**NC Department of Insurance
Office of the State Fire Marshal - Engineering Division
1202 Mail Service Center, Raleigh, NC 27699-1202
919-647-0000**

Wall Space v. Wall Countertop Spaces

Code: 2014 Electrical Code
Section: 210.52(A)

Date: November 20, 2017

Question 1 Illustration

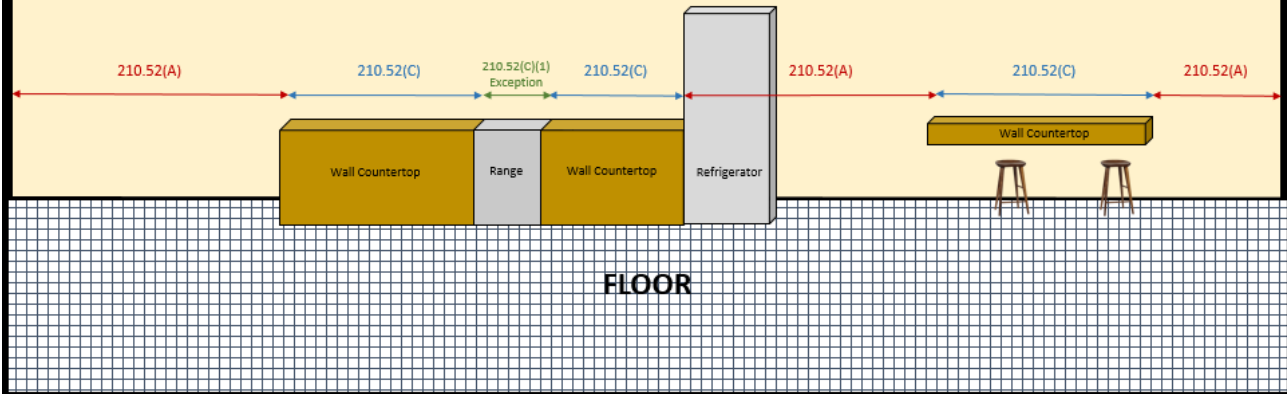
A kitchen countertop that is attached to a wall has receptacles mounted above the countertop that comply with section 210.52(C). Are additional receptacles required to be added below the countertop to serve the wall space described in section 210.52(A)?

No. Section 210.52(A)(2) describes the “wall space” within a dwelling including in the kitchens, pantries, breakfast rooms, dining rooms, and similar areas. Section 210.52(C)(1) describes the dwelling’s “wall countertop space” in the kitchens, pantries, breakfast rooms, dining rooms, and similar areas.

In areas designated for food preparation, the “wall space” described in section 210.52(A)(2) and the “wall countertop space” described in section 210.52(C)(1) each possess electrical needs that are distinguishable from each other due to the type of appliances that typically utilize such receptacles.

Thus, the receptacles in the areas along the walls of a kitchen are either regulated by section 210.52(A) or by section 210.52(C) depending on whether a wall countertop exists in such area. In no case will the sections 210.52(A) and 210.52(C) both regulate the same wall area of the kitchen.

Question 2 Illustration

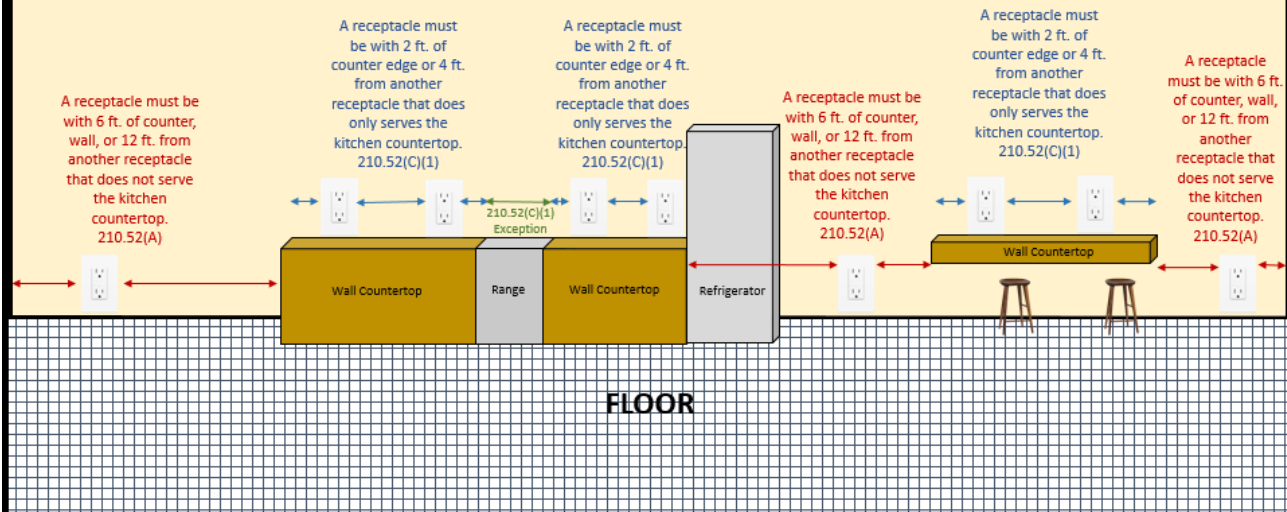
A kitchen countertop that is attached to a wall has receptacles mounted above the countertop that comply with section 210.52(C). There is at least 2 feet of wall space (area without a kitchen countertop) regulated by section 210.52(A) beside the countertop. Can any of the countertop receptacles be used to satisfy the wall space receptacle requirements of 210.52(A) if the countertop receptacles are not located more than 5 ½ feet above the floor?

No. Section 210.52(A)(4) prohibits the use of the receptacles installed for wall countertop space in the kitchens, pantries, breakfast rooms, dining rooms, and similar areas from simultaneously satisfying the wall space receptacle requirements of 210.52(A).

Question 3(a) Illustration

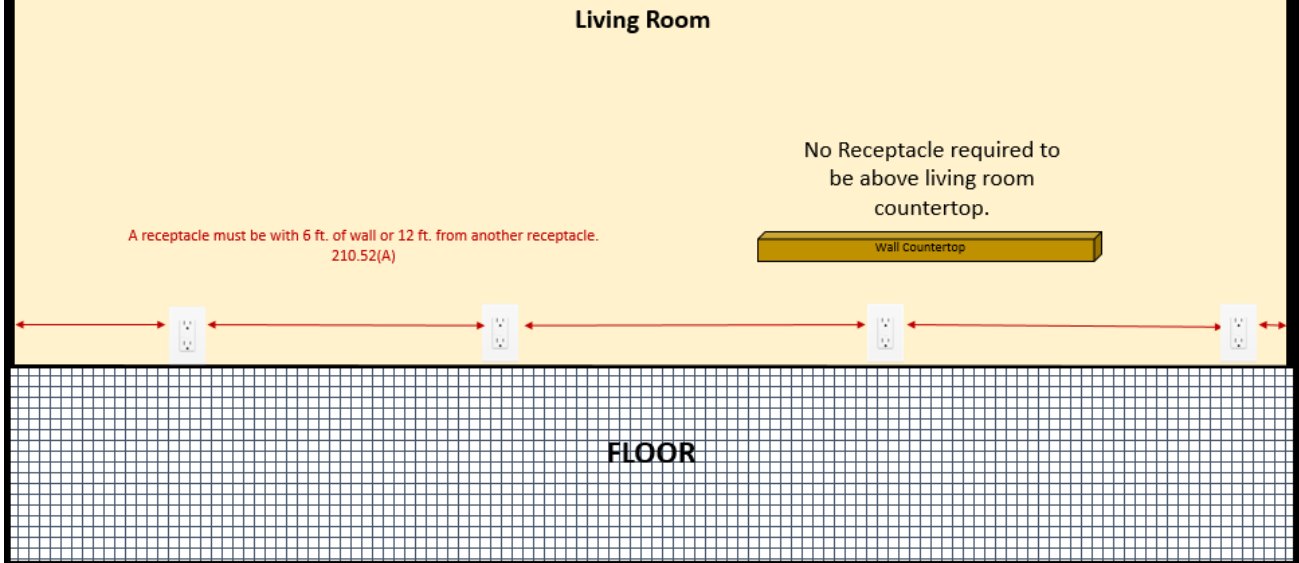
A living room countertop that is attached to a wall has receptacles mounted above the countertop that are 4 feet above the finished floor. Does section 210.52(A)(4) require additional receptacles to be added below the countertop to serve the wall space described in section 210.52(A)?

A living room countertop that is attached to a wall has receptacles mounted below the countertop that are 1 foot above the finished floor. Does section 210.52(A)(4) require additional receptacles to be added above the countertop to serve the wall space described in section 210.52(A)?

No. Section 210.52(A)(4) only prohibits the receptacles specified in section 210.52(C) from simultaneously satisfying the wall space receptacle requirements of 210.52(A). Receptacles serving the living room countertop are not specified by section 210.52(C). Section 210.52(C) only concerns countertop space in the kitchens, pantries, breakfast rooms, dining rooms, and similar areas.
